# UNITED STATES PATENT AND TRADEMARK OFFICE

APPLICATION NO.	FILING DATE	FIRST NAMED INVENTOR	ATTORNEY DOCKET NO.	CONFIRMATION NO.
10/618,133	07/11/2003	Lixiong Li	ARA-US-P1	4427
44702	7590	02/22/2006	EXAMINER	
OSTRAGER CHONG FLAHERTY & BROITMAN PC 250 PARK AVENUE, SUITE 825 NEW YORK, NY 10177			SAVAGE, MATTHEW O	
			ART UNIT	PAPER NUMBER
			1724	
DATE MAILED: 02/22/2006

## Office Action Summary

FIG. 3

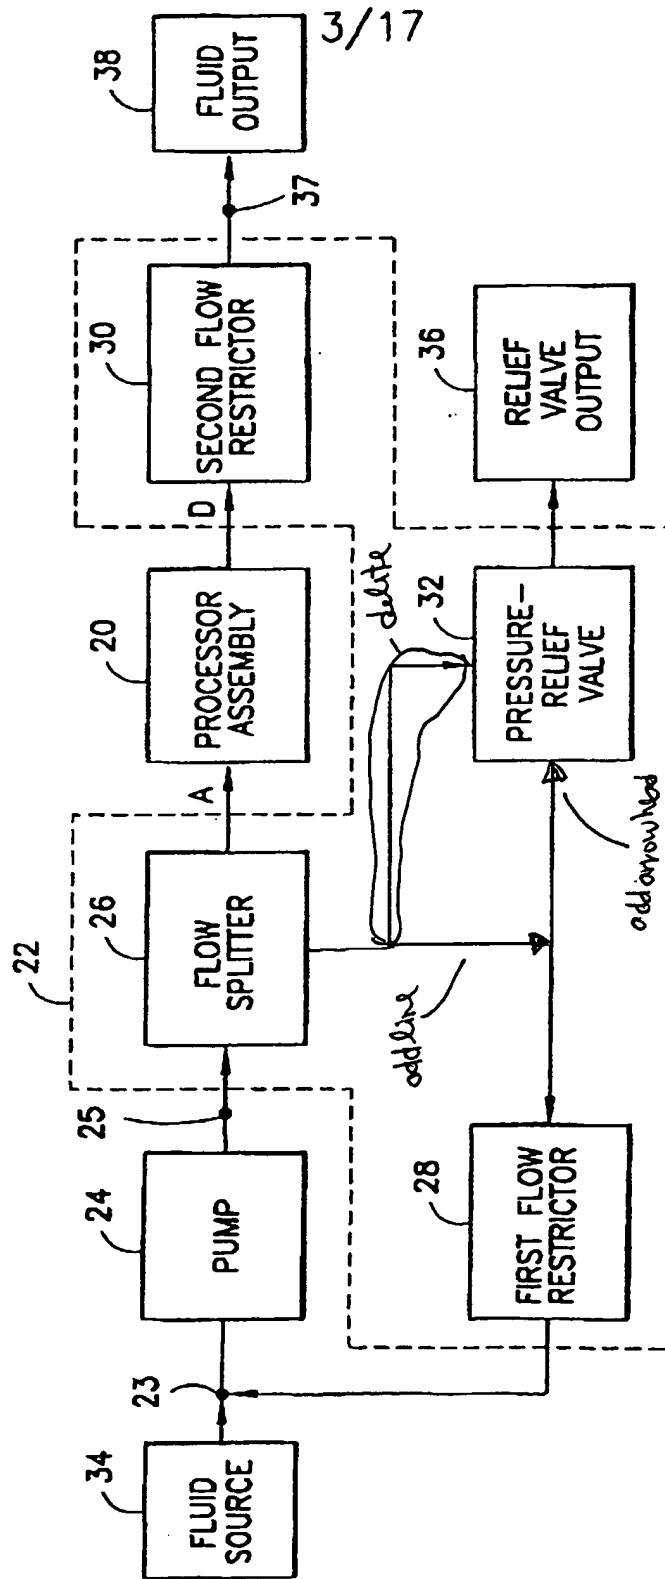
The amendment filed On 12-7-05 is objected to under 35 U.S.C. 132(a) because it introduces new matter into the disclosure. 35 U.S.C. 132(a) states that no amendment shall introduce new matter into the disclosure of the invention. The added material which is not supported by the original disclosure is as follows: the original specification fails to have basis for a pressure relief valve having a single inlet and a single outlet as shown in proposed amended FIG. 3.

The proposed amendment to FIG. 3 concerning the pressure relief valve filed on 12-7-05 has not been approved by the examiner for the reasons set forth above.

Do not enter.  
ms

Applicant is required to cancel the new matter in the reply to this Office Action.

FIG. 10A

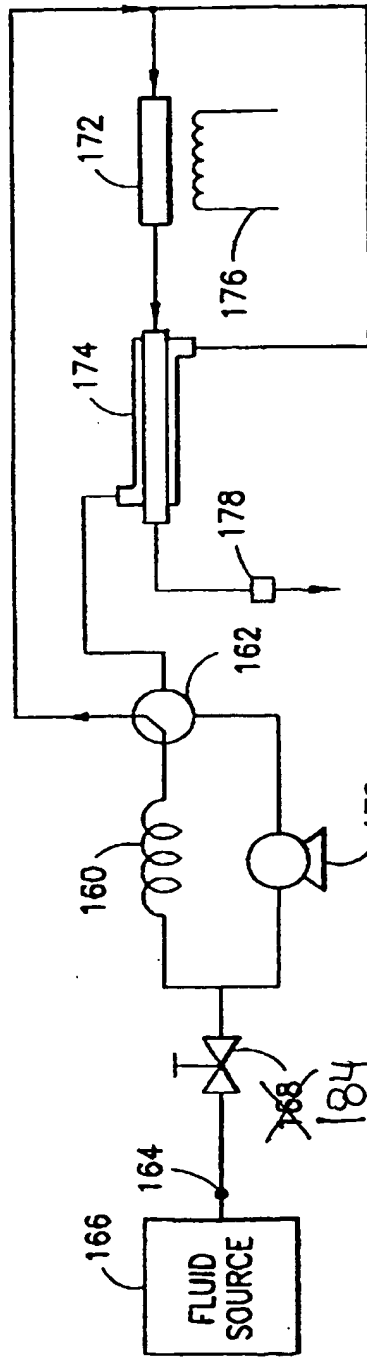
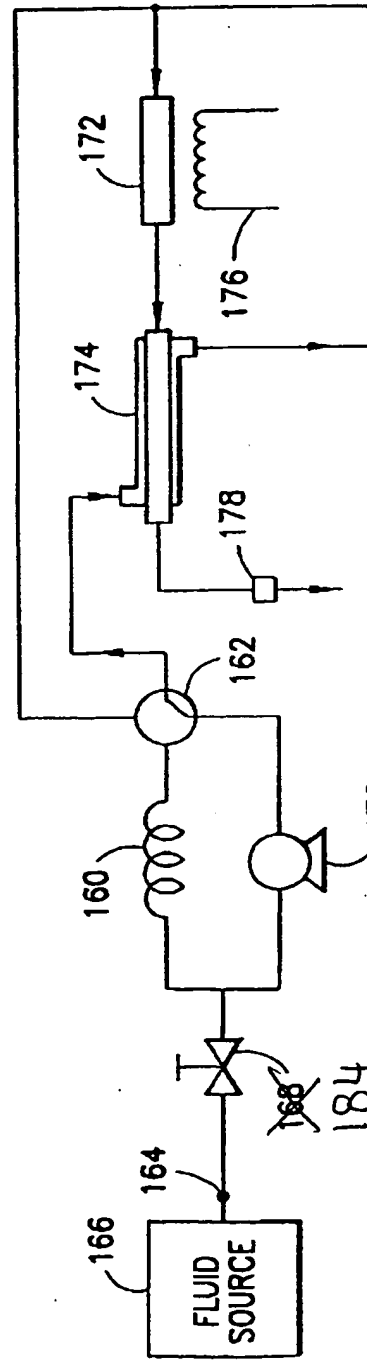
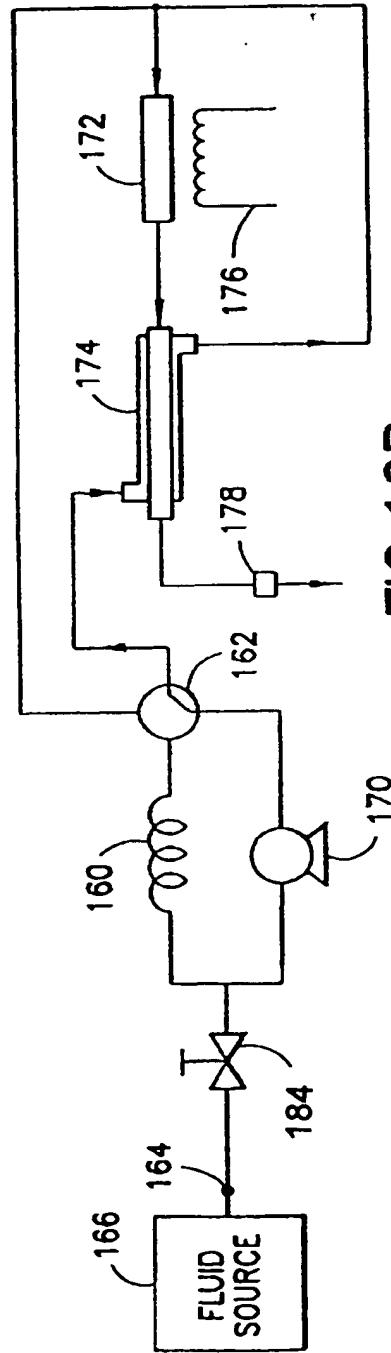
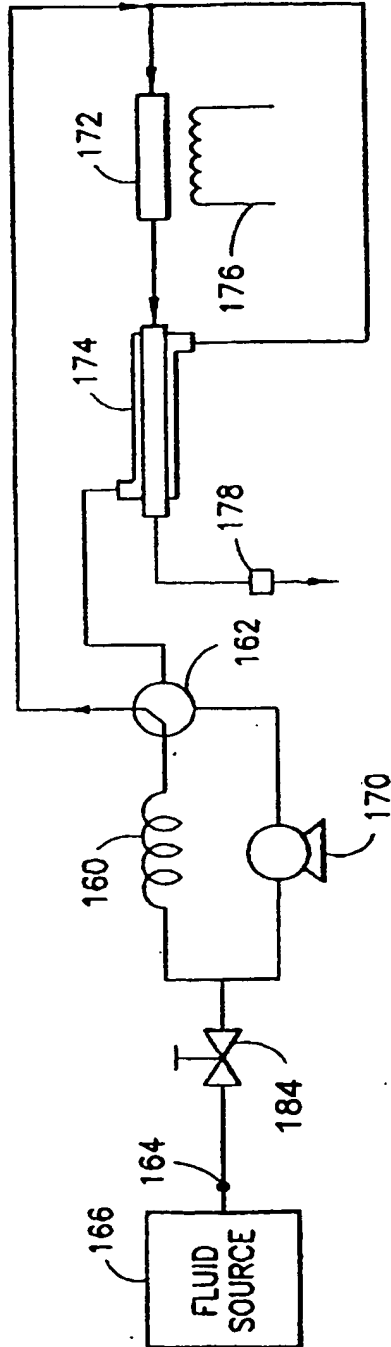
The proposed amendments to FIGS. 10A, 10B, 11A filed on 12-7-05 have been approved by the examiner.

OK to enter.  
WJG

FIG.11A

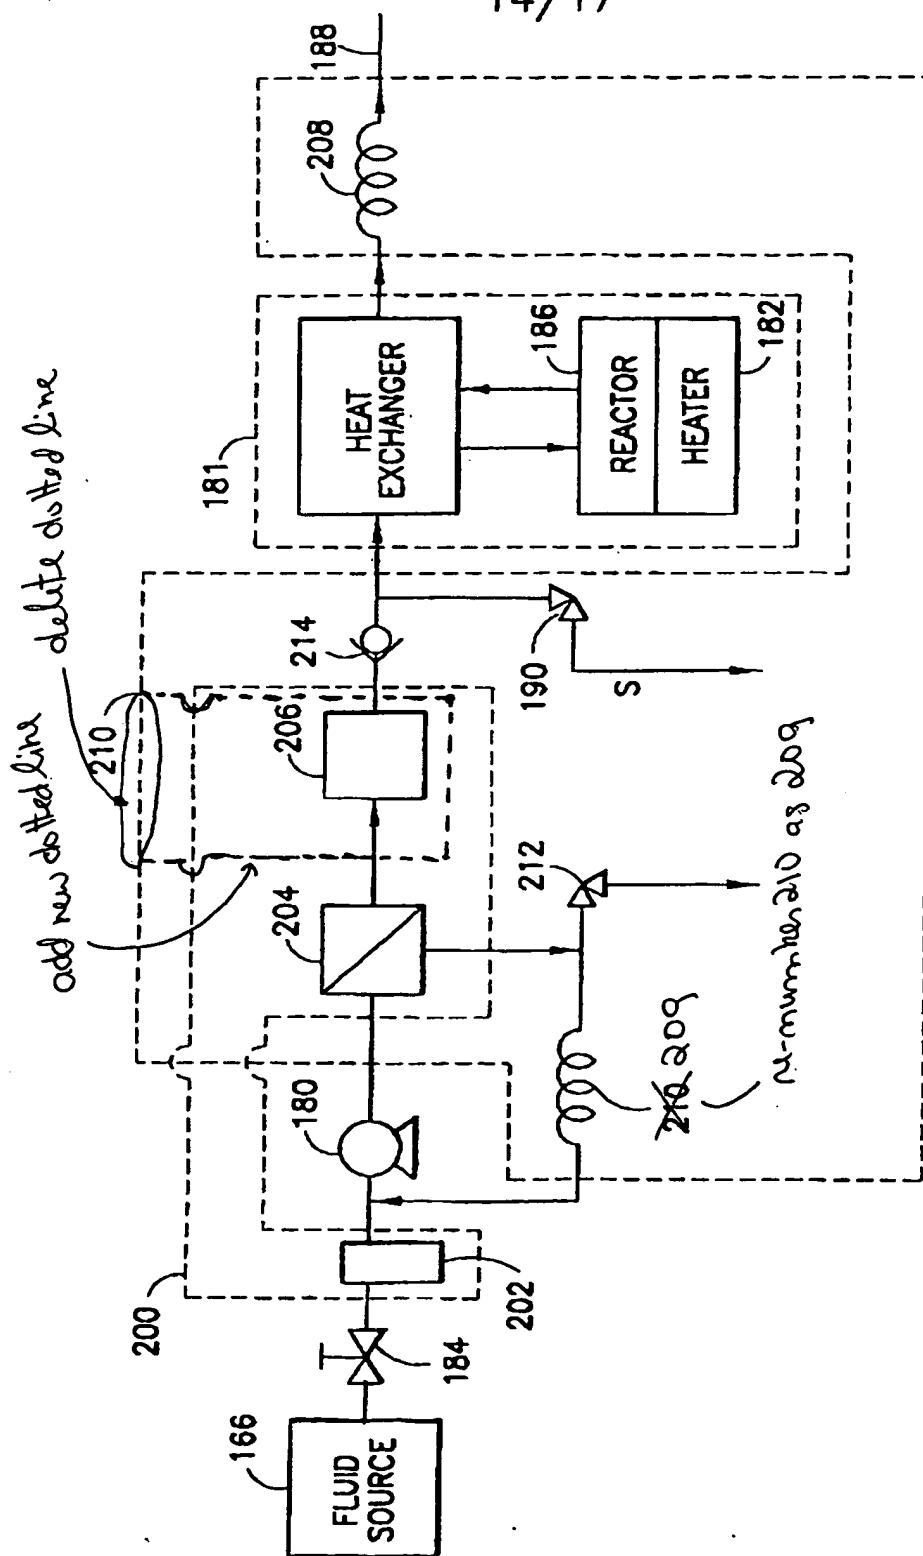
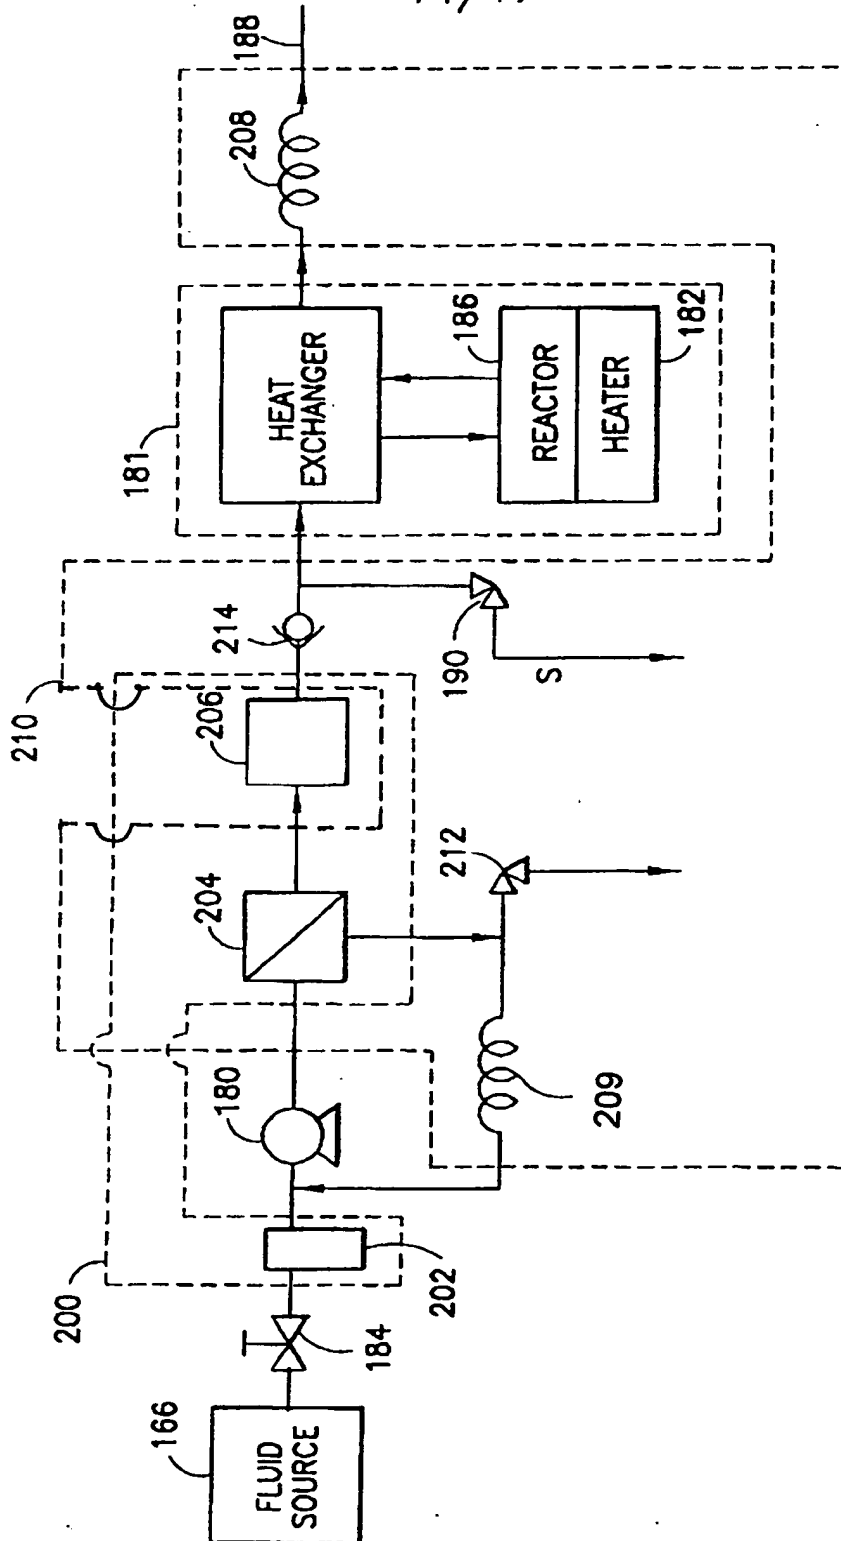
OKay to enter.  
ms

FIG. 11A *Okay to install.*  
Mg

FIG.3

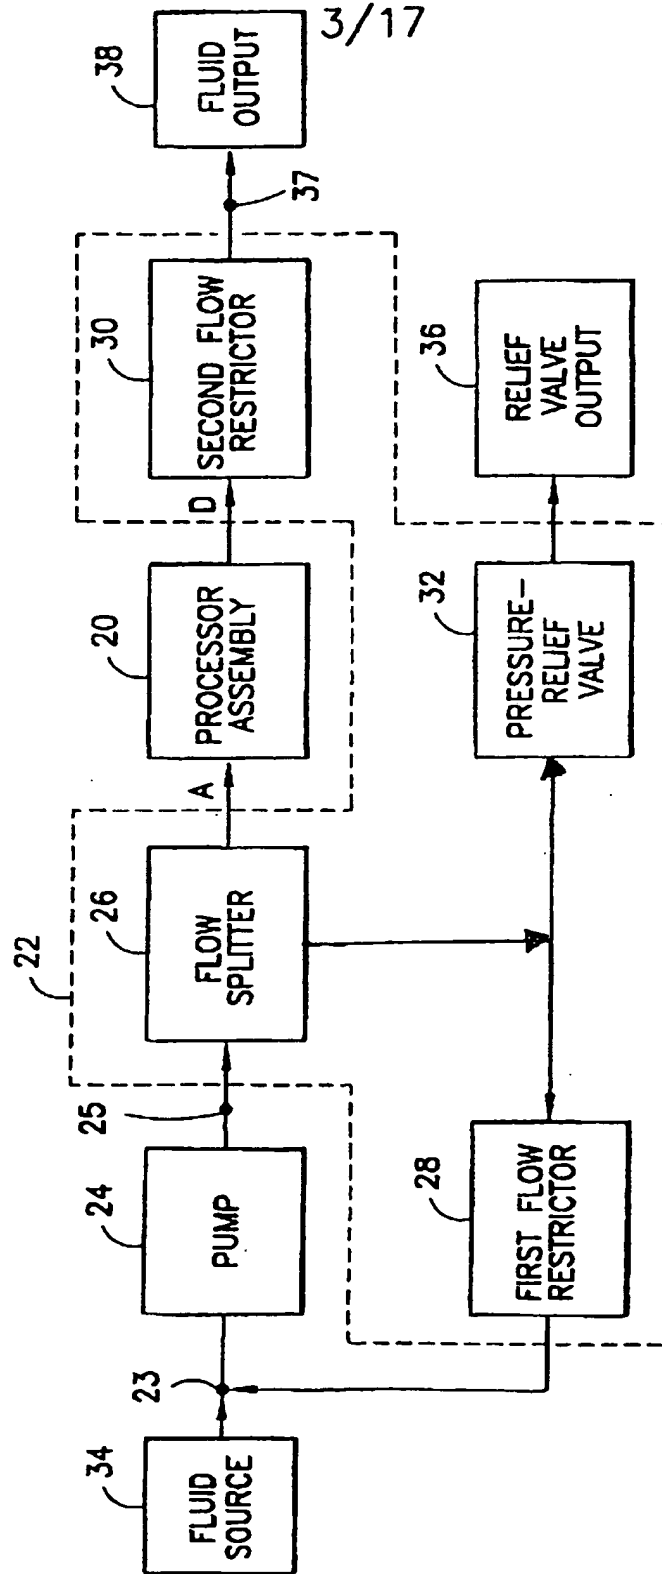
The proposed amendment to FIG. 3 filed on 12-7-05 out-lining the process control system 22 has been approved by the examiner.

Okay to enter.  
148
